# Service Bulletin

Bulletin No.: 18-NA-054

**Subject: Momentary Sharp Deceleration During 1-2 Upshift or a Momentary Neutral During 2-4 Upshift, Transmission Stuck in 2nd Gear (fluid below 32°F), Malfunction Indicator Lamp (MIL) Illuminated - DTC P2820 Set During Cold Ambient Temperatures**

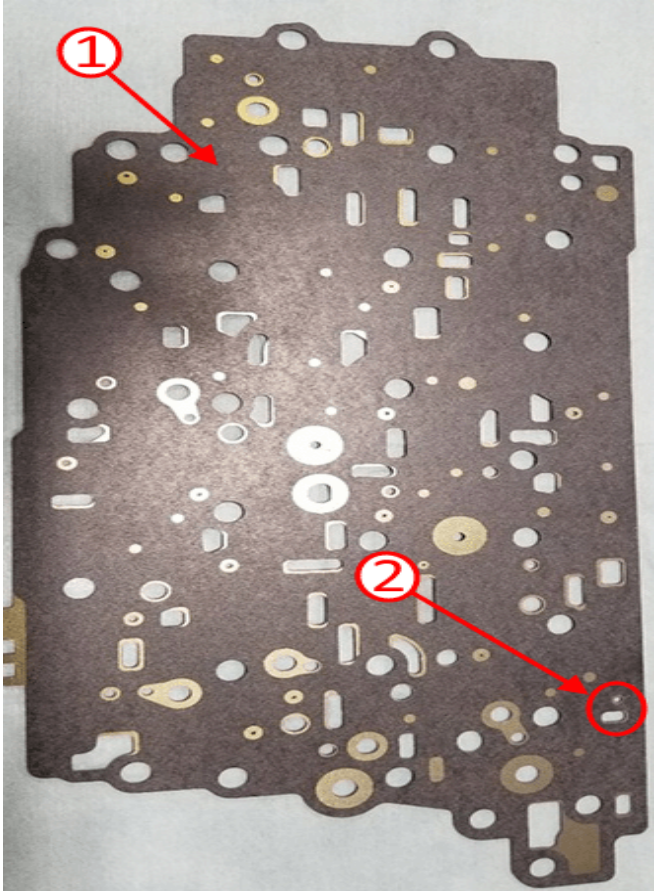
<p>Cause</p>	 <p style="text-align: right;">4885522</p> <p>This condition may be caused by the spacer plate (1), located between the valve body and the transmission case as an orifice (2), that is undersized.</p> <p>⇒ The consequence is the clutch select moves slowly to release the selectable one way clutch, which causes a momentary transmission tie up during the 1-2 upshift.</p>
<p>Correction</p>	<p>Inspect valve body spacer plate orifice for proper size and replace as necessary following current SI instructions.</p>

- If the 0.5 mm orifice is validated, replace the separator plate.

- If the 2.0 mm orifice is validated, refer to SI for further diagnostics.
